Product Change Notice (PCN)

PCN Number: **PCN-0454917R-01**

Product(s) Affected: *PJ-085AH*

F-723-001

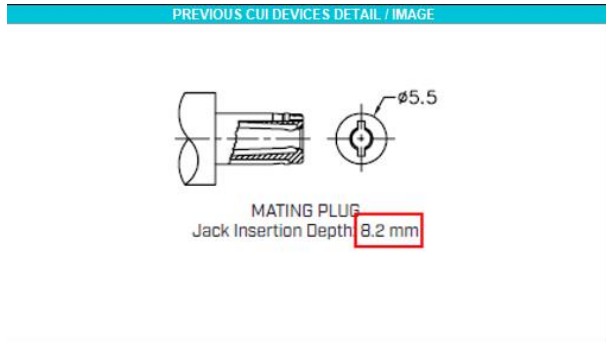
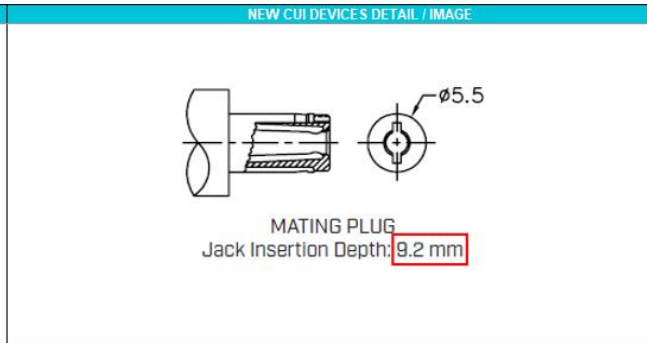
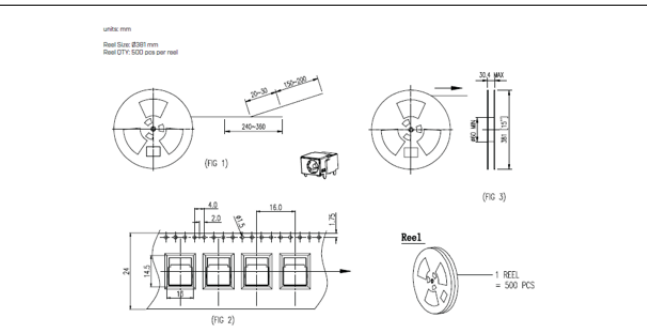
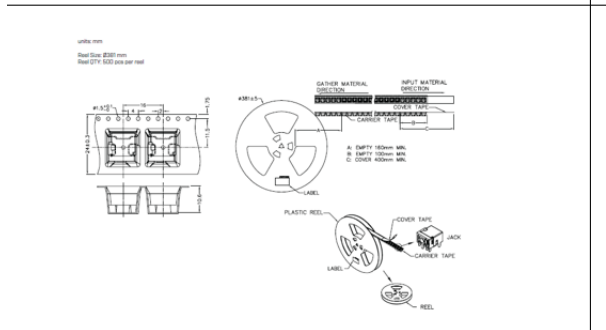
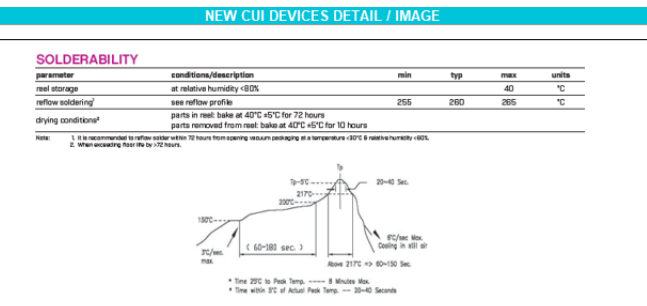
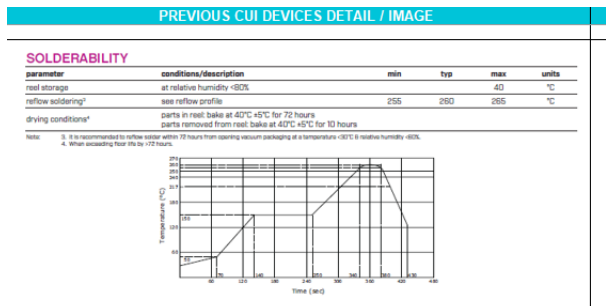
Description of Change: *Minor Housing and footprint differences. Material Change on the housing and terminals. See image Below*

MATERIAL	PLATING
center pin	copper	nickel
terminal 1	brass	silver
terminal 2	copper alloy	silver
terminal 3	brass	silver
terminal 4	copper alloy	silver
shield A	brass	nickel
shield B	stainless steel	
insulator	PA10T

DESCRIPTION	MATERIAL	PLATING
center pin	brass	nickel
terminal 1	brass	silver
terminal 2	phosphor bronze	silver
terminal 3	brass	silver
terminal 4	phosphor bronze	silver
shield A	brass	nickel
shield B	stainless steel	clean
housing	PA10T (UL94V-0)	black
